Planning & Transportation Commission

Staff Report (ID # 14599)

Summary Title: Action Item: ADU Code Changes to PAMC Chapter 18.09

Title: PUBLIC HEARING/LEGISLATIVE: Review and Discuss Potential Ordinance Changes to Palo Alto Municipal Code Chapter 18.09, Accessory and Junior Accessory Dwelling Units. Environmental Assessment: Exempt from the provisions of the California Environmental Quality Act (CEQA) pursuant to Public Resources Code Section 21080.17 and CEQA Guidelines sections 15061(b)(3), 15301, 15302 and 15305 (Continued From July 13, 2022).

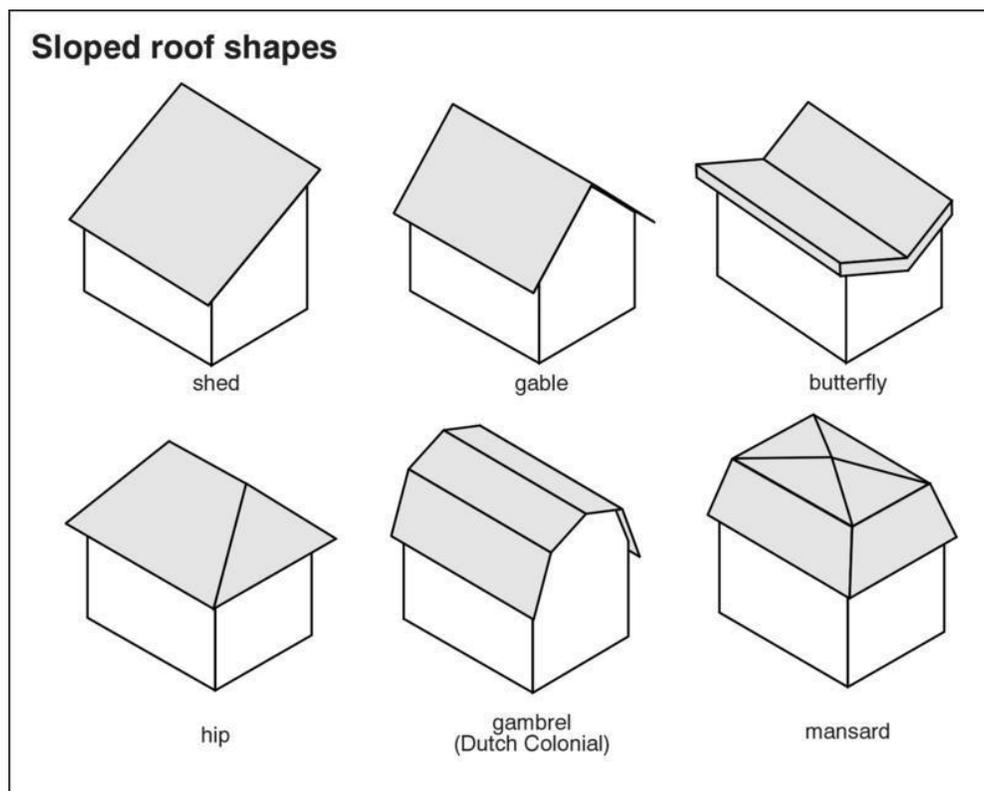
For example, if an existing structure was 11 feet and two inches tall, then the height could be increased by only 10 inches, rather than one foot. This section also would

require retention of the existing roof line and style. For example, a structure with a shed roof cannot be converted to a gabled roof. Staff believes that this will help to mitigate potential massing and aesthetic impacts upon adjacent neighbors. Neighbors will already be familiar with the existing structure's outline, albeit slightly taller and closer to their property (see example roofline images below).

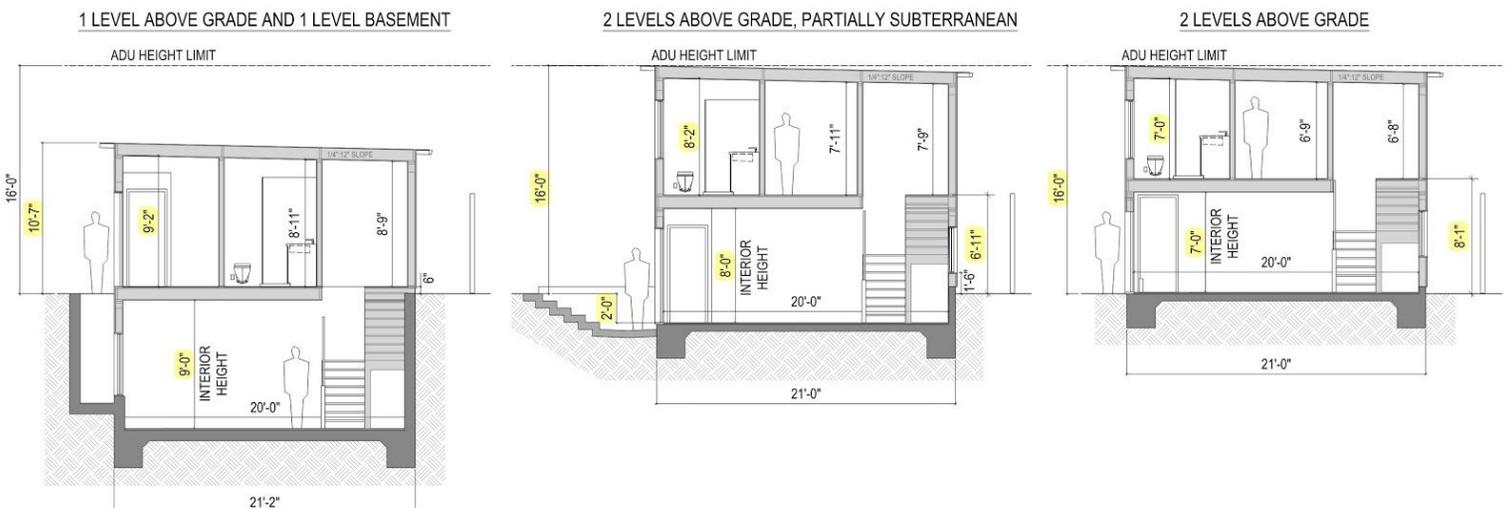
- c. Consider adopting language similar to that used in Santa Cruz:

- i. ADUs higher than one story may be up to 22' tall at the peak, measured from average grade, and any portion of the structure that exceeds 16' in height must be set back a minimum of 5' from the side yard property line and 10' from the rear yard property line.
- ii. Exception: An ADU that faces an alley or street can be up to 22' tall and any portion of the structure that exceeds 16' in height must be set back 5' from the side and rear property lines.
- iii. Detached New Construction ADUs higher than one story shall limit the major access stairs, decks, entry doors, and windows to the interior of the lot or an alley if applicable. Windows that impact the privacy of the neighboring side or rear yards should be minimized or otherwise restricted as in (b.) above

5. Minimal increase to non-conforming structures

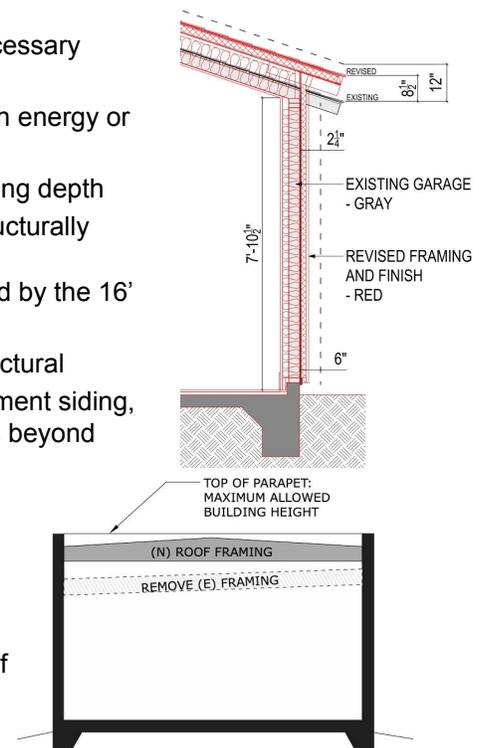
- a. Create an allowance to avoid complete demolition or unnecessary complexity due to energy or structural upgrades
 - i. Clarify that it can only be accessed for compliance with energy or structural obligations

- 1. Grant an additional 12" of height – increase framing depth above top plate rather than hanging, which is structurally complex and reduces ceiling heights.

- 2. Note that the structure height will still be restricted by the 16' height limit.
 - 3. Grant an additional 6" in plan on any side for structural seismic sheathing, exterior insulation, or replacement siding, so long as no portion of the structure encroaches beyond the property line.

- ii. Add a clarification regarding structures with existing parapets. A non-conforming portion of the structure may be modified up to the height of the existing parapet. This can be done without creating an increased impact to neighbors. Previous interpretation of 'shrink-wrap' rules should not apply to recessed roof areas below the top of the parapet. This flexibility will allow the interior to be a reasonable residential height.

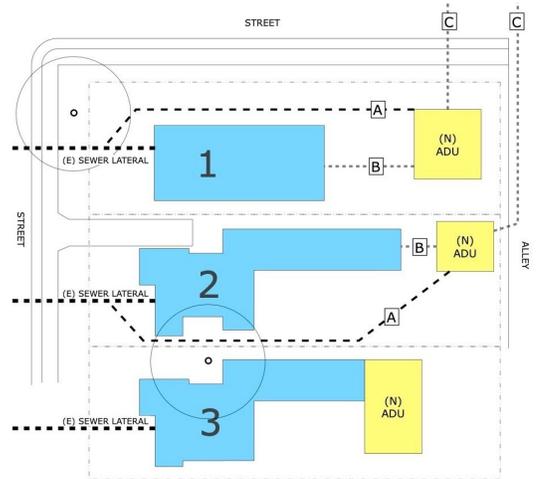
- c. Routing of utilities at the discretion of property owner (rear alley or another alternate to avoid disruption to landscape or trees)

- i. This graphic compares three lots with an alley behind. Parcel 3 has an attached ADU and the sewer may connect to the main house line. There is no impact to the site. Parcels 1 and 2 have detached ADUs and are currently required to run their sewer line shown as 'A', around the main house, and out to the street at the front yard. This is highly problematic, especially if there are protected trees on site. A reasonable option would be to allow the sewer line placement shown by the 'B' or 'C' routing.
